GRANDVIEW RESERVE FILING NO. 1

Engineering Review
10/27/2021 3:01:26 PM
dsdrice
JeffRice@elpasoco.com
(719) 520-7877
EPC Planning & Community
Development Department

Cursory comments - see
comment letter also.

EARLY GRADING & EROSION CONTROL PLANS

COVER SHEET

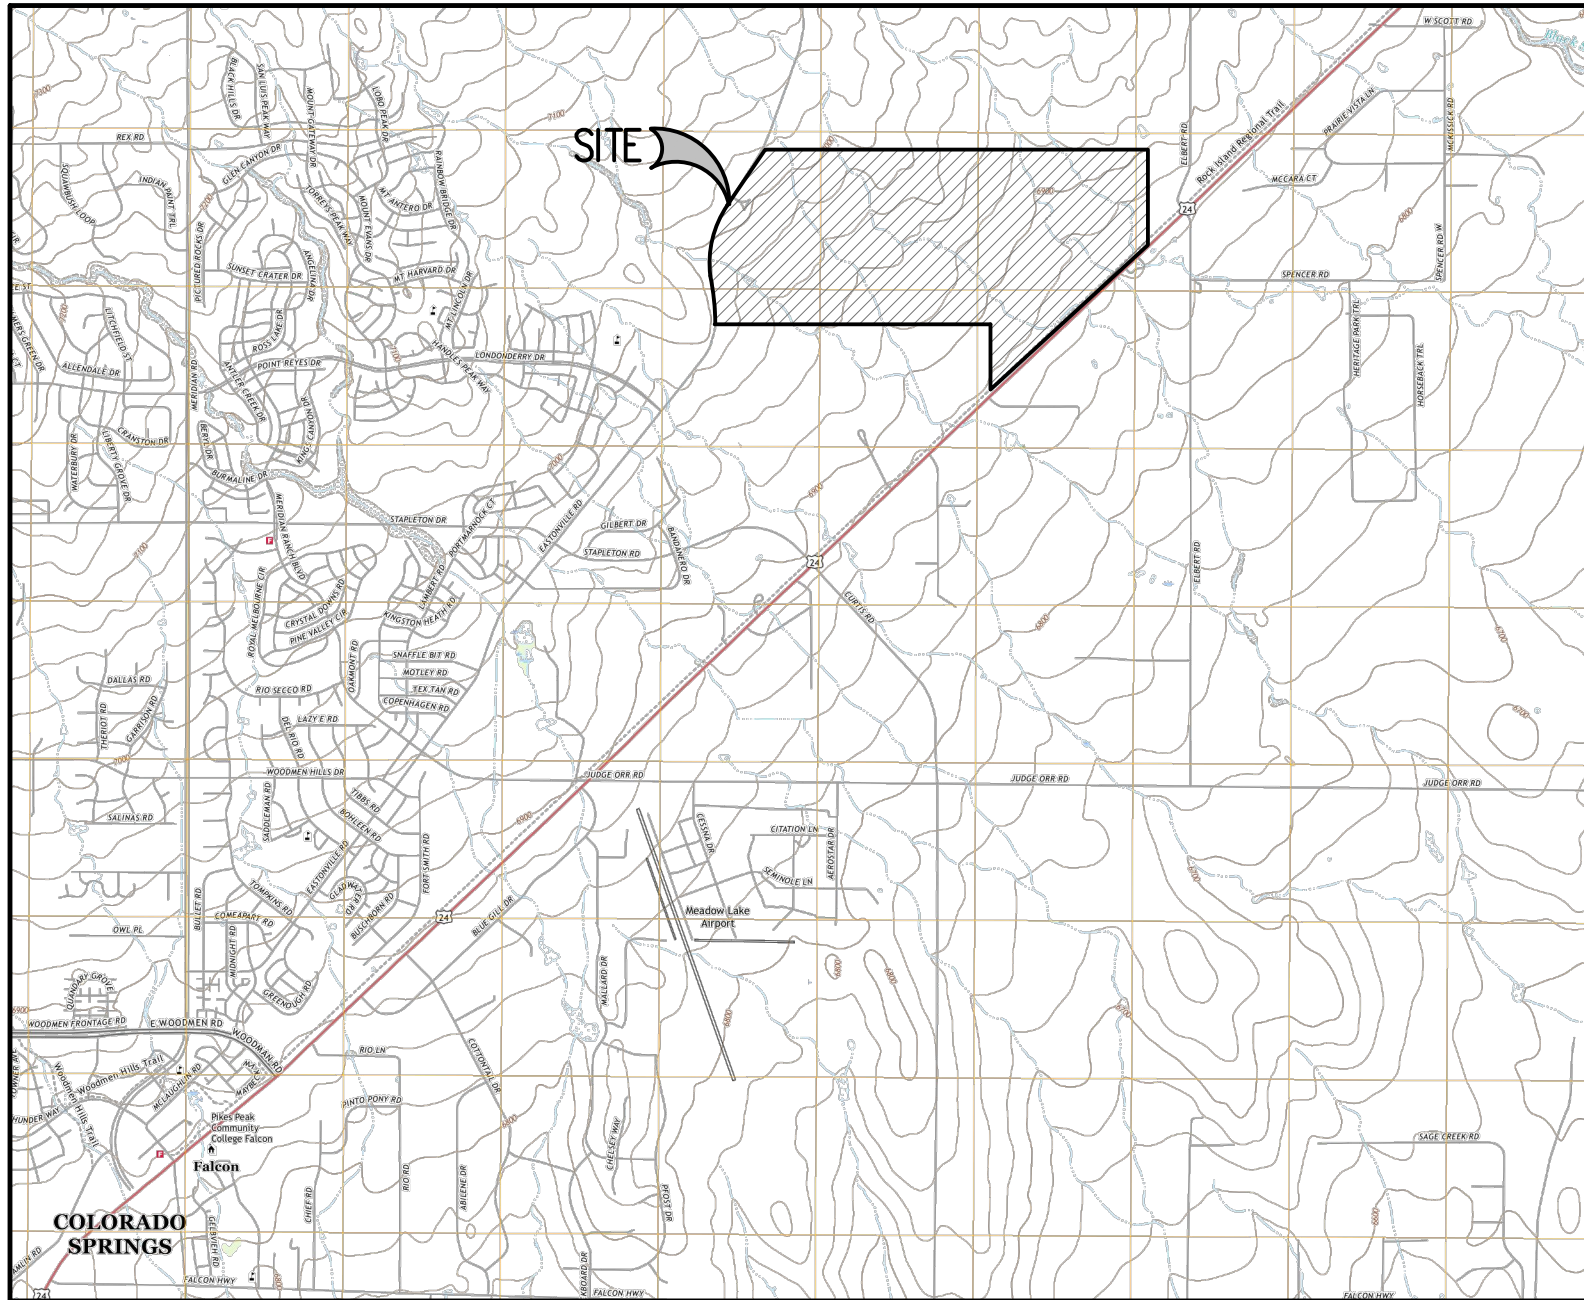
PCD Fig No. added

NOTES

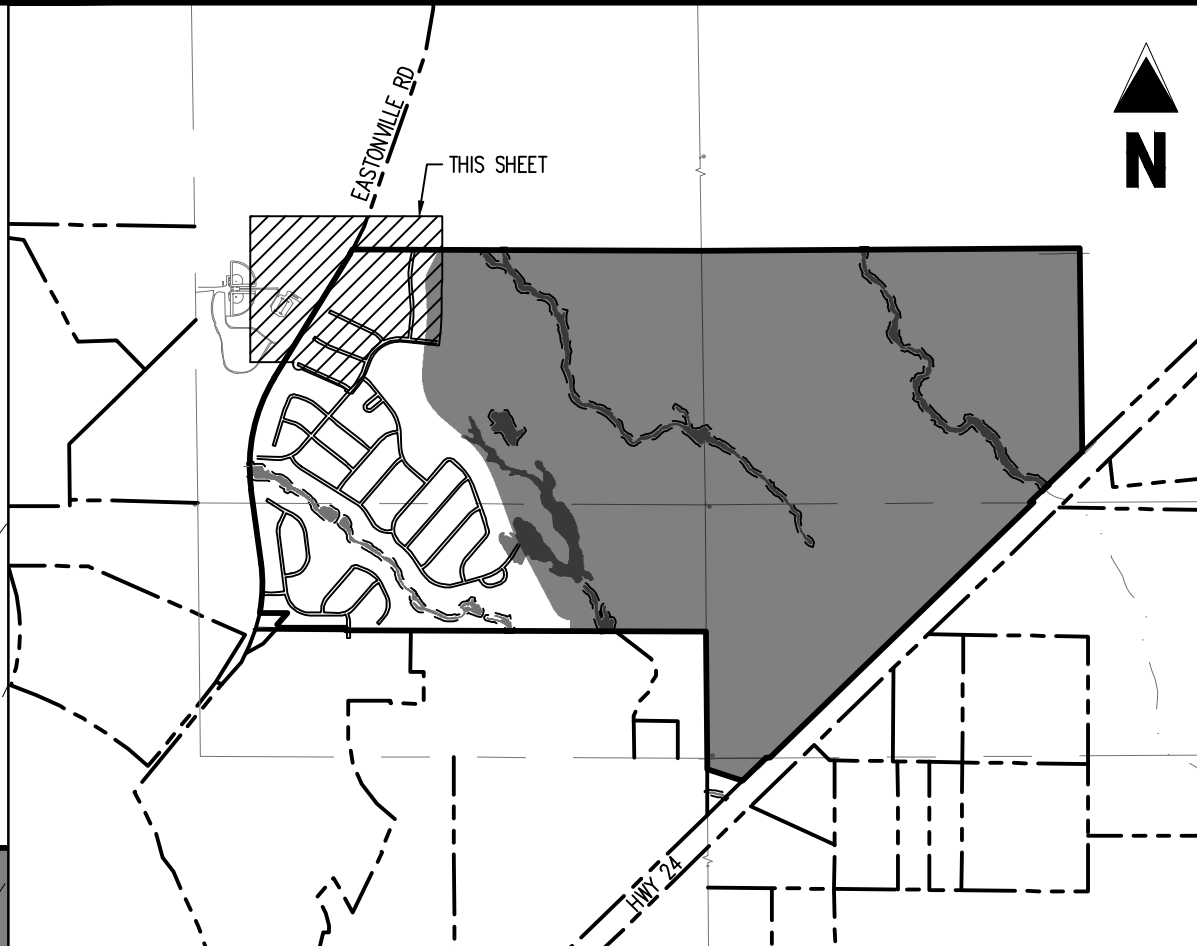
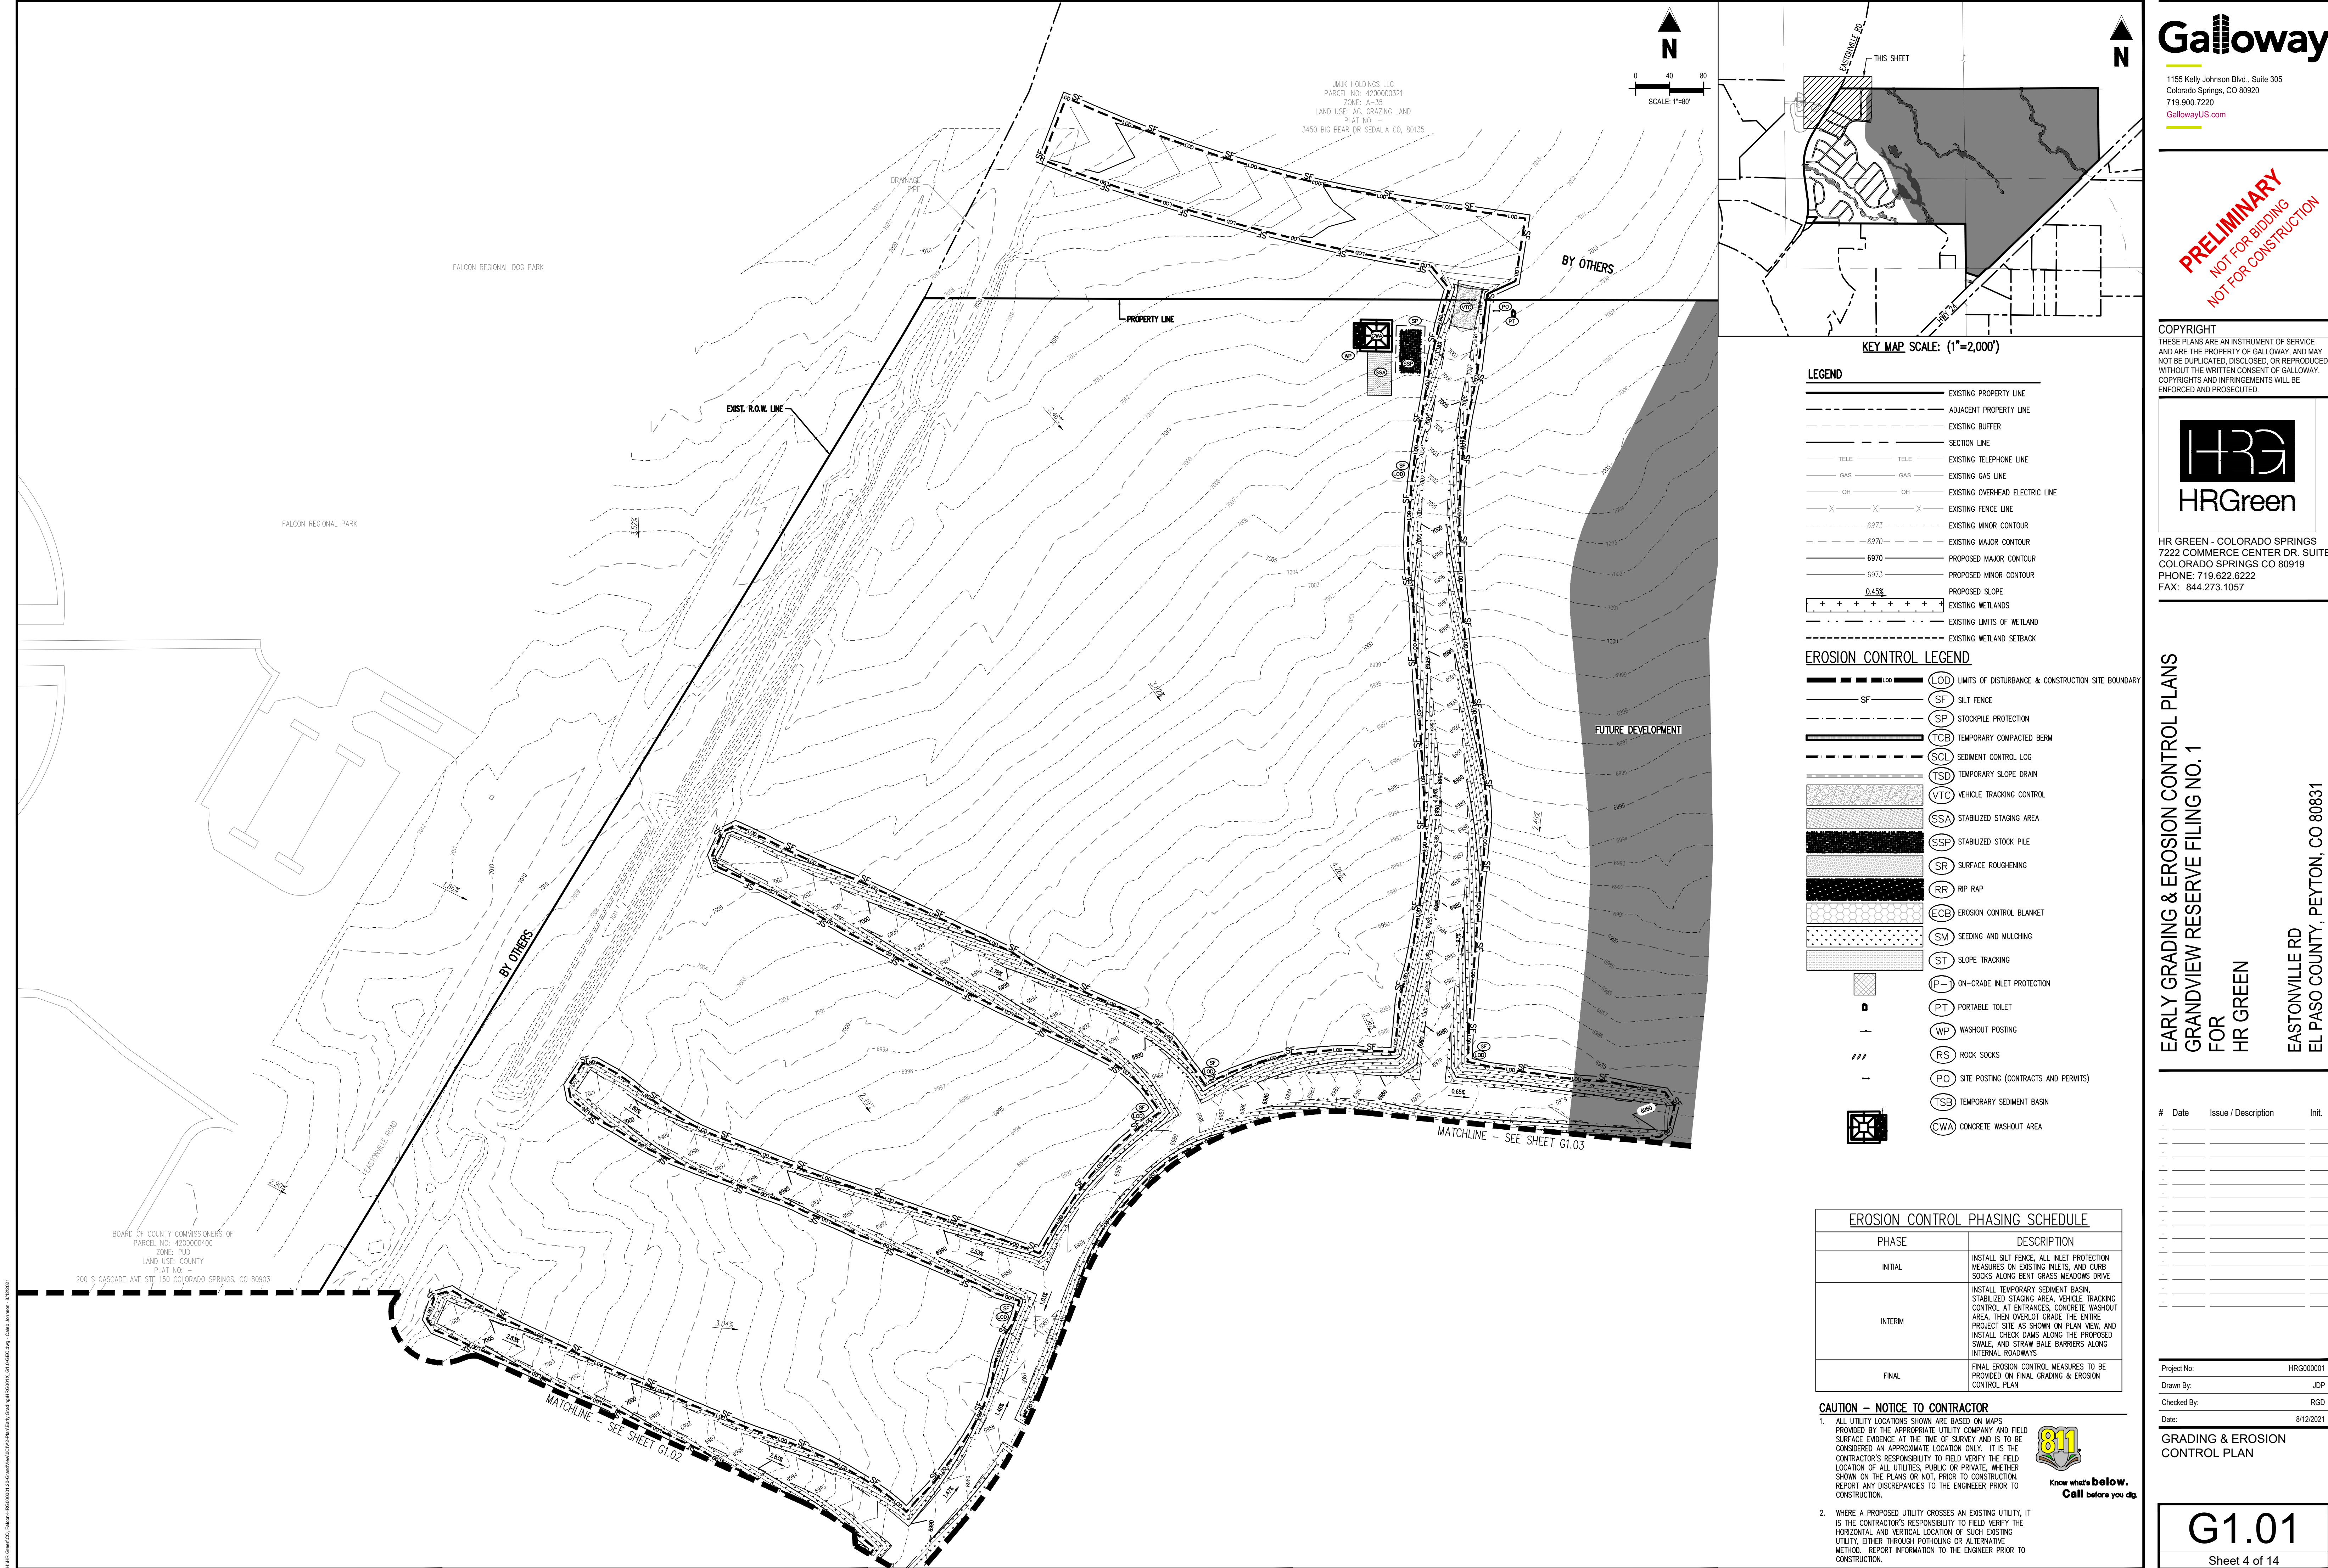
Engineer's statement
has been revised
